**PLANNED RESIDENTIAL UNIT DEVELOPMENT PLAN**

The Development Review Coordinator review has been completed for the proposed Redlon Park subdivision. The review has included several submissions of revised drawings by the applicant's engineering consultant, Pinkham & Greer Consulting Engineers, Inc. Based on this review the following comments are provided:

**SUBJECT:** Redlon Park; Site Plan, Subdivision, P.R.U.D. Review; Cottage Park Inc. Applicant

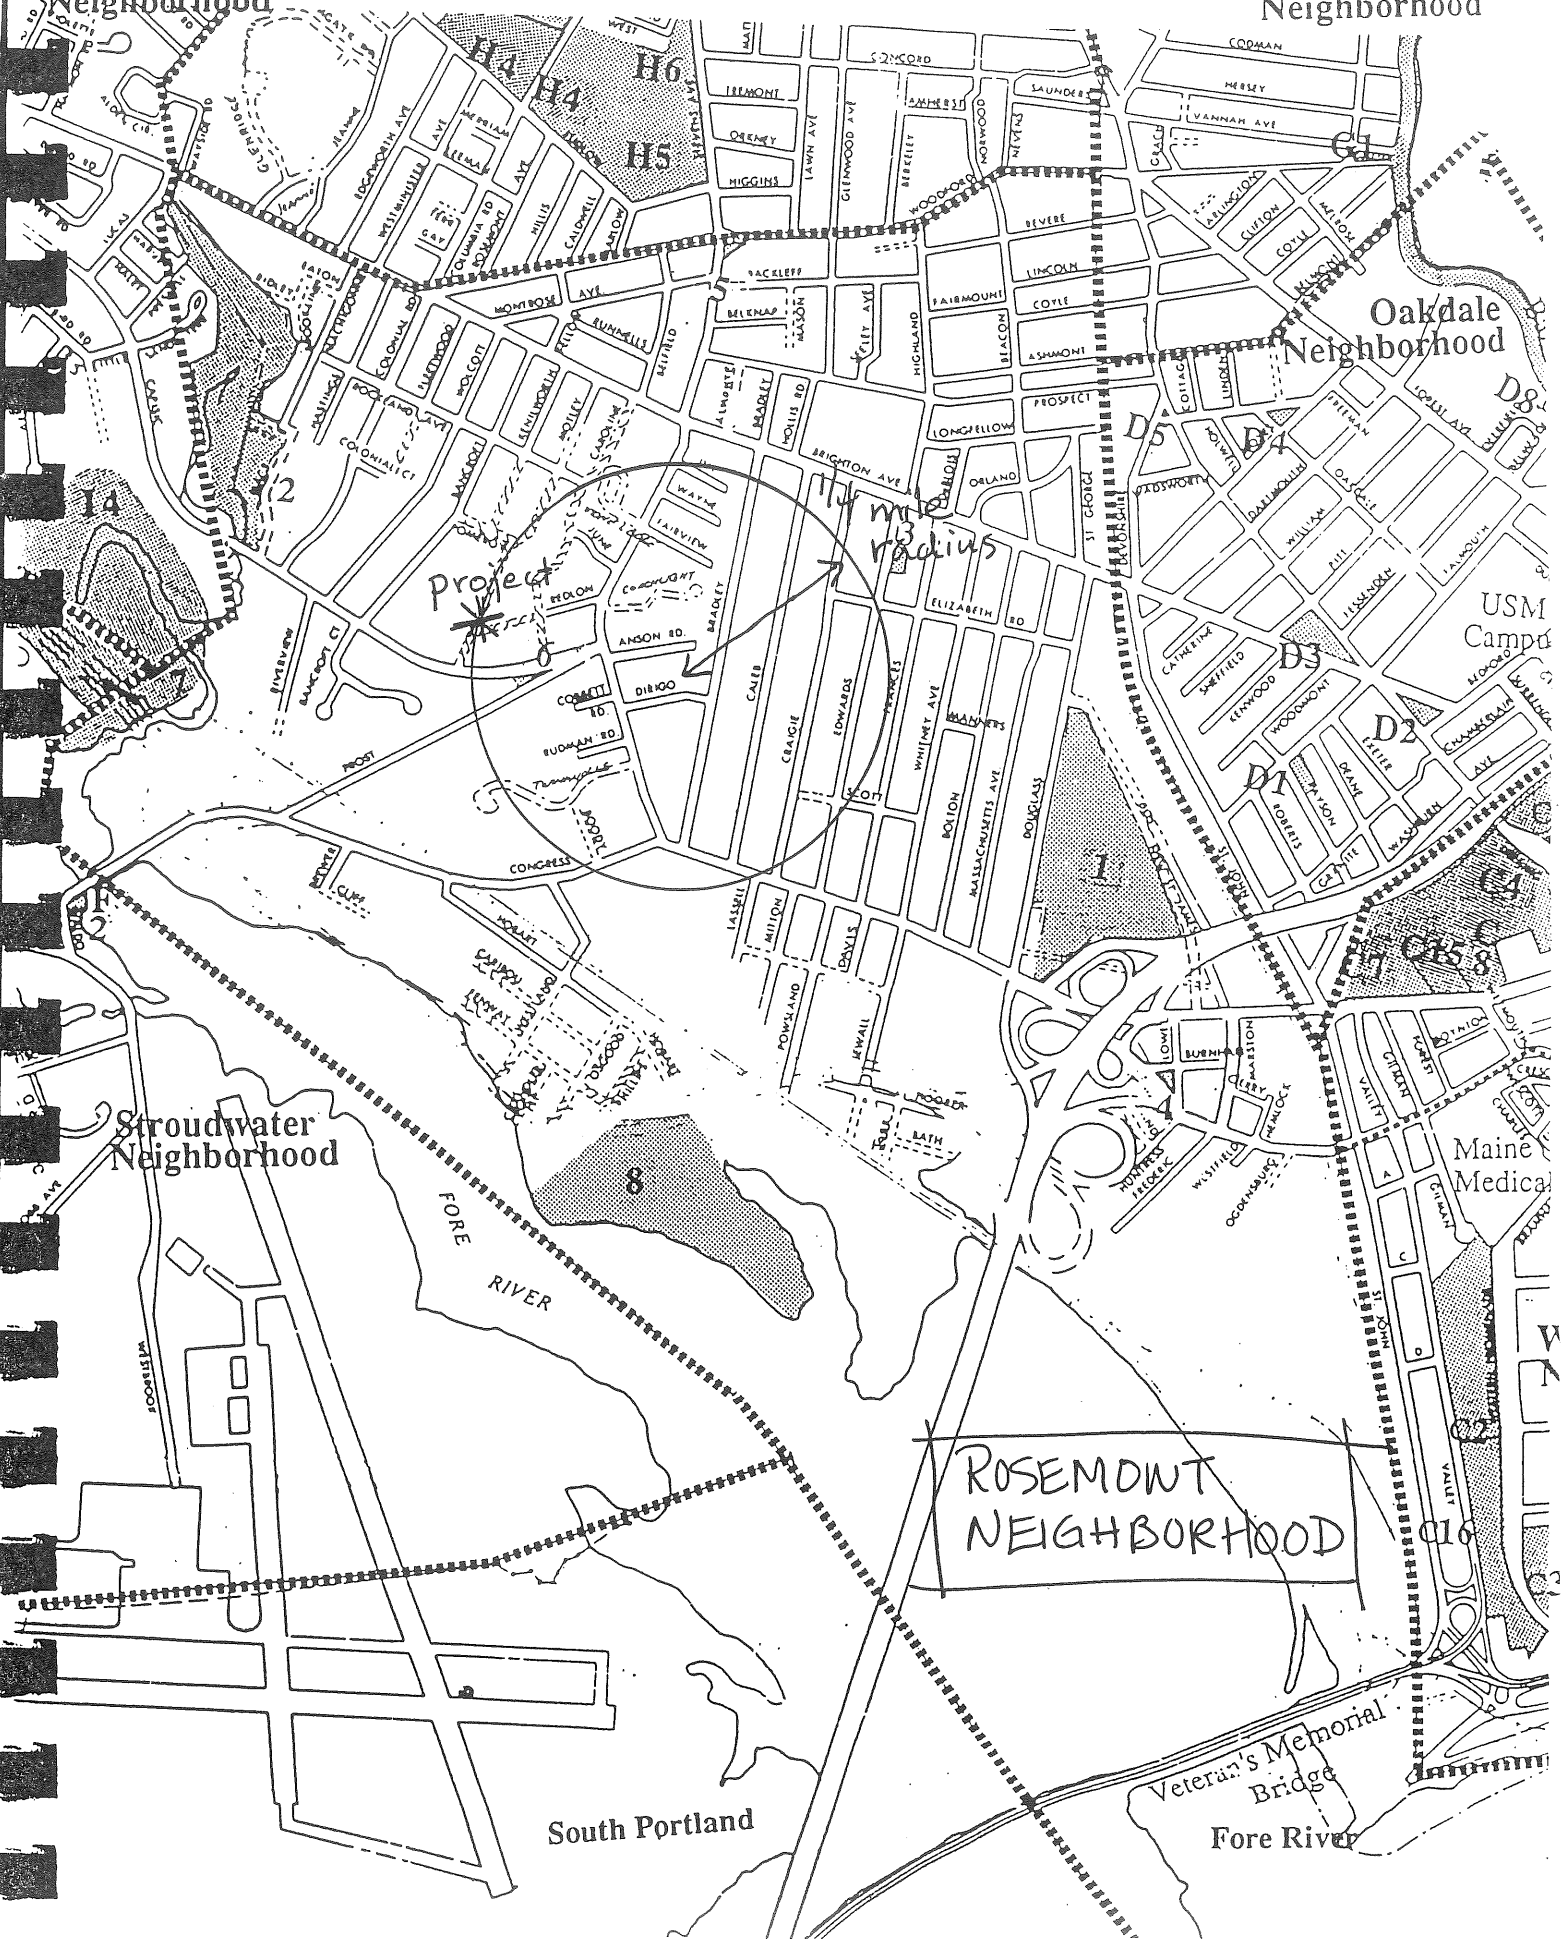
- The roadway and right-of-way have been reconfigured to accommodate a potential connector to Motley Street.
- The change in the right-of-way has resulted in a reconfiguration of all the lots. House locations shown on the original plan have also been modified.
- Common open space has been relocated near lot 3 and includes a 40' by 60' basketball court. The total land area of the common space is shown as 24,068 sq. ft. although a significant portion is wetland.
- The revisions in the layout plan has resulted in grading and drainage changes. Revised drainage calculations have been submitted. Detention pond 1 was deleted but the storage capacity of pond 2 was increased accordingly. The drainage analysis states that "the peak flows leaving the site are reduced and the ponding along Bancroft Street is reduced for the 10 and 25 year storms".
